Stair flip study · the main stair turned round: start and arrival at the NORTH end, next to the lift · Taif / Palm House V8.0 (work) · STUDY ONLY

ADOPTED 2 Nov 2026 (owner): option B, the freed landing as F-b, the balustrade, the store door onto the riwaq, the half-landing window, the entrance side light, the entry cupboard removed; applied to the design files. Owner's idea, 1 Nov 2026 · the same well (2.75 × 5.7 on axes, 2.525 × 5.50 clear), the same 22 risers × 0.164 / goings 0.28, flights 1.21 clear · nothing in the design files changes until the owner decides · all sizes assumed

1 · The two options on the ground floor

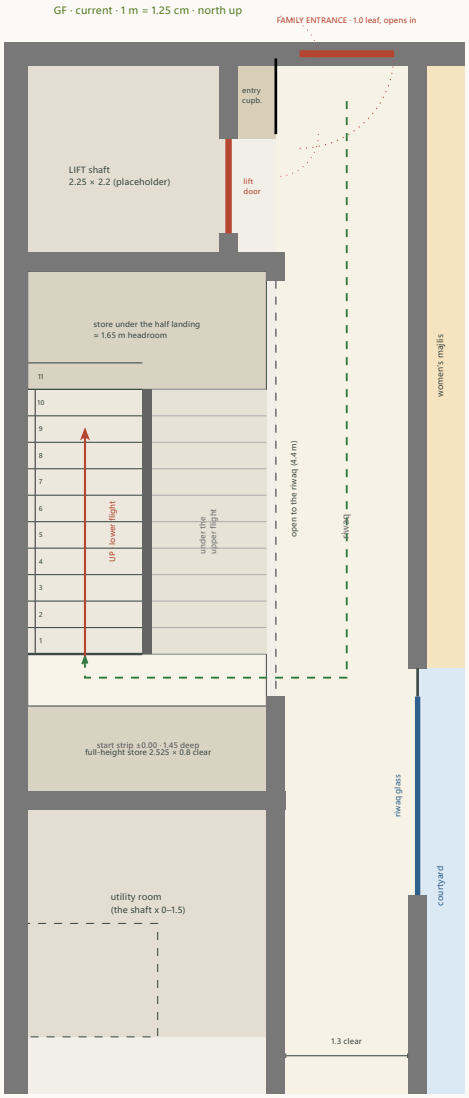
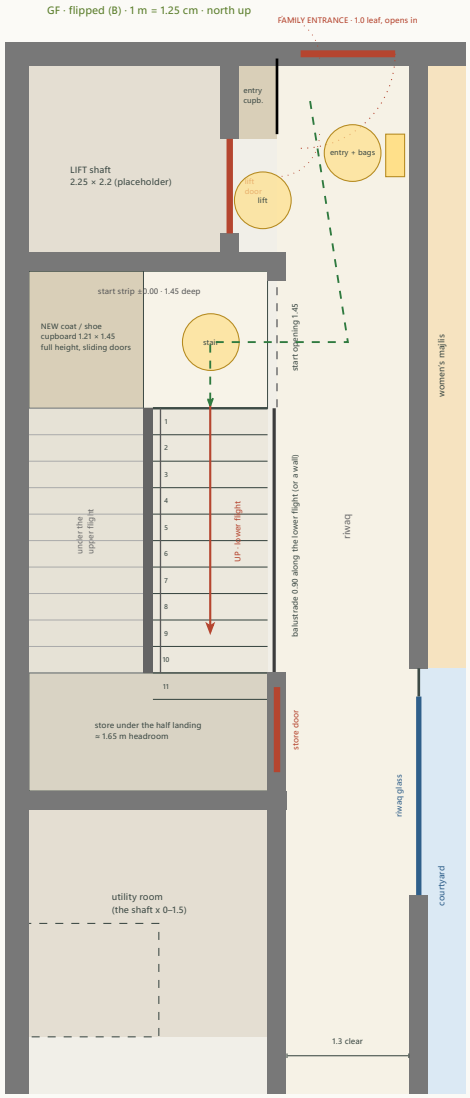
- **Current:** the lower flight on the **west** half starts at the **south** end (first riser y 6.35); the person comes along the riwaq, enters the well through its open east side (4.4 m open) and turns west onto the flight; in front of the first riser only **0.55 m** before the full-height store's wall (the start is really made from the side, under the upper flight's high end). Half landing at the north end (+1.80, a 1.65 m store below it, opening east onto the riwaq); the full-height store 2.525 × 0.8 clear at the south end.

- **Flipped (B, recommended of the two flips):** the lower flight on the **east** half starts at the **north** end (first riser y 3.75), **straight off the lobby**: a 1.45 m opening in the x 2.75 line between the lift notch and the flight, a start strip 1.45 m deep in front of the first riser. The lower flight rises along the riwaq side (a 0.90 balustrade on the riwaq, or a wall: the owner's choice); the half landing at the south end with its 1.65 m store (door onto the riwaq at y 6.7–7.6, in front of the courtyard glass; or into the utility room). The **west half of the start strip** (1.21 × 1.45, full height) becomes a **coat / shoe cupboard** beside the family entrance (sliding doors onto the strip).

- **Flipped (A):** the mirror image only (the lower flight stays west): the person crosses the whole strip to the far half before climbing; no cupboard. Not recommended; everything else below holds for both.

2 · Congestion test at the flipped start (drawn)

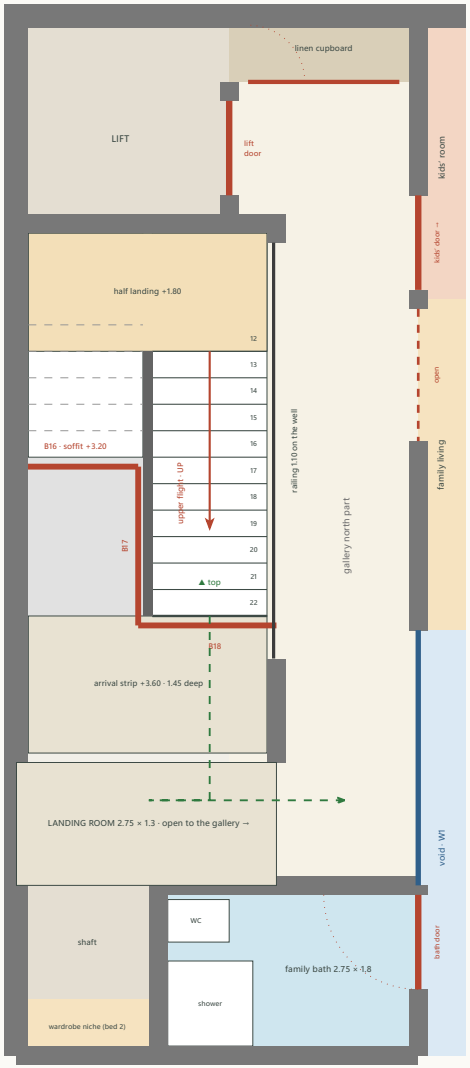
Three people at once: **one waiting for the lift** in the 0.50 m notch in front of its sliding door, **one coming in with bags** inside the family entrance's 1.0 m swing, **one starting up the stair** on the start strip, with the **entry cupboard's two 0.45 leaves open** into the lobby. Clear widths, not axes: the lobby **1.3 m** between the lift / cupboard wall face and the women's majlis wall face (the notch adds 0.5 m at y 0.9–2.2); the start opening **1.45 m**; the first riser **1.21 m** wide; the entrance **0.9 m** clear. The three stand in three separate zones along the lobby (y 0–1.0 the door swing, y 0.9–2.2 the lift notch, y 2.3–3.75 the start strip); the stair starter passes 0.3 m south of the lift waiter and never crosses the entrance swing: **OK**. Two people can pass in the 1.30 m lobby (0.60 + 0.60 + 0.10) but a person with two bags blocks it for a moment, as today. **Furniture up the stair:** the 90° turn from the 1.30 lobby through the 1.45 opening onto the 1.21 flight is a tight but normal house stair turn; the current start (0.55 m strip, sideways) is worse.

First floor · the arrival, the opening and its trimmers, the freed landing · current vs flipped

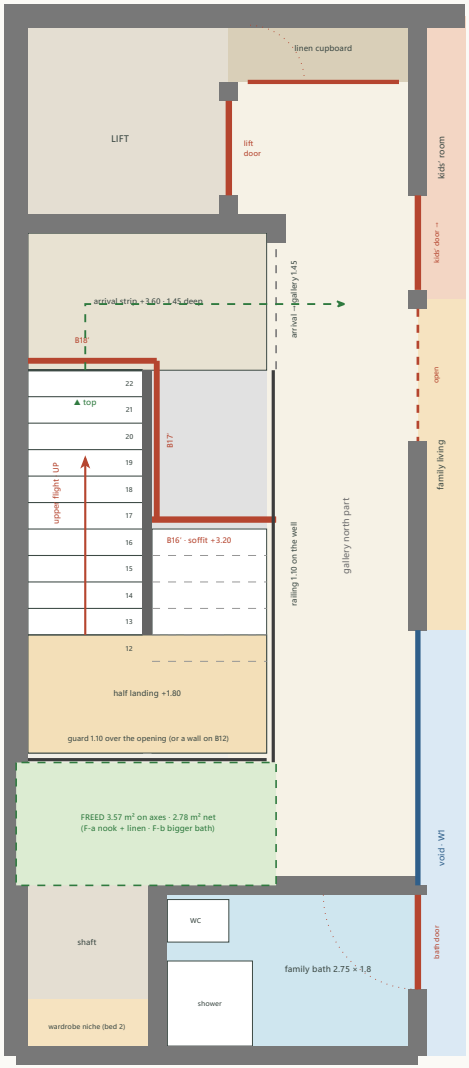
- **Current:** the upper flight (east half) lands at +3.60 on the arrival strip (y 6.35–7.8), then the **landing room** (2.75 × 1.3, y 7.9–9.2) and east into the gallery; the bedrooms and the family bath are at hand, the kids' room, the living and the lift are 6–9 m north along the gallery.

- **Flipped (B):** the upper flight (west half) lands on the arrival strip at the **north** end (y 2.3–3.75); the strip opens east onto the gallery's north part (1.45 m), **0.10 m south of the lift notch**: the lift's first-floor door, the linen cupboard (its leaves swing south, 0.6 m), the kids' room door (opens into the room) and the family living's opening are all within 1–3 m. The gallery's north part (1.30 clear) carries the arrival traffic as it carries the lift's today; the linen leaves and the lift door are 1.0 m north of the arrival: no clash. The railing on the well runs from the arrival (y 3.75) to the south wall; the landing room is **freed** (§ 5).

- **Current (studies/structure.typ):** an L-shaped opening ≈ 8.2 m²: the west half open from the north wall to B16 (y 4.85), the east half open to B18 (y 6.45); B16 (0.20 × 0.40, soffit +3.20) from the west wall to B17; B17 (x 1.29, on the lower flight's side of the split) from B16 to B18; B18 (y 6.45) from B17 to the riwaq-line beam B10 (x 2.75).

- **Flipped (B):** the **same opening turned round** (≈ 8.2 m²): the east half open from B16′ (y 5.33) to the south wall, the west half from B18′ (y 3.65) to the south wall. **B16′** (y 5.33) from the riwaq-line beam B10 to B17′; **B17′** (x 1.49, on the east, lower flight's side of the split: never over the upper flight) from B16′ to B18′; **B18′** (y 3.65, the arrival edge) from the west wall to B17′. The same zigzag, mirrored: one beam-on-beam junction at each end of B17′, the torsion the engineer's; B18′ now bears on the west wall (as B16 does today) and B16′ on B10 (as B18 does today). **Neither better nor worse** for the structure: the spans (1.3–1.6 m) and the bearings are the same kind. **Not verified.**

- **Slab edges:** the arrival strip (1.45 × 2.525) spans between the north wall beam B11 (y 2.2) and B18′; over the lower flight's first six treads the slab spans from B18′ to B16′ (1.6 m) between B10 and B17′. The guard round the opening: the railing on x 2.75 from the arrival south to y 7.9, the well's south wall line y 7.9 (a 1.10 guard or a wall on B12), the upper flight's balustrade on the split.

Headroom · a section along the lower flight for each option · the slab 0.2 thick (soffit +3.32), the trimmers 0.20 × 0.4 (soffit +3.20), the finish 0.08 · over the full walking width of every tread

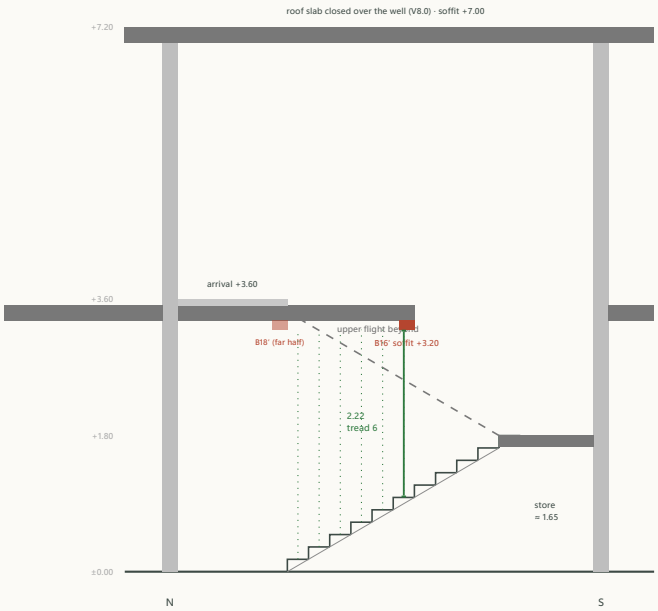
The upper flight, the half landing and the arrival are under the open well (the roof slab's soffit +7.00): ≥ 3.4 m. Minimum of this option: **2.22 m** at tread 6 under the trimmer, across the whole 1.21 m width (the trimmer spans the half); B17 over the inner 0.10 strip of treads 1–5: ≥ 2.38 m.

The upper flight, the half landing and the arrival are under the open well (the roof slab's soffit +7.00): ≥ 3.4 m. Minimum of this option: **2.22 m** at tread 6 under the trimmer, across the whole 1.21 m width (the trimmer spans the half); B17′ over the inner 0.10 strip of treads 1–5: ≥ 2.38 m.

Verdict on the headroom: identical in both options (**2.22 m** at tread 6 under the trimmer, 2.83 m at tread 3 under the slab; ≥ 2.10 required, the 2.20 aim just met) because the flip mirrors the geometry: the trimmers sit in the same places relative to the treads. **The flip neither improves nor worsens the trimmers.** What would improve both: trimmers 0.20 × **0.30** (soffit +3.30 → **2.32 m** at tread 6) if the engineer accepts a 0.30 depth for the 1.3–1.6 m spans, or the slab edge moved one tread (the opening 0.28 m longer, ≈ 0.35 m² more void, tread 6 under open sky → the minimum moves to tread 5: 2.38 m). Both options can take either. The walls' handrails run the full flights (0.08 off the walls); the central handrail on the 0.10 split.
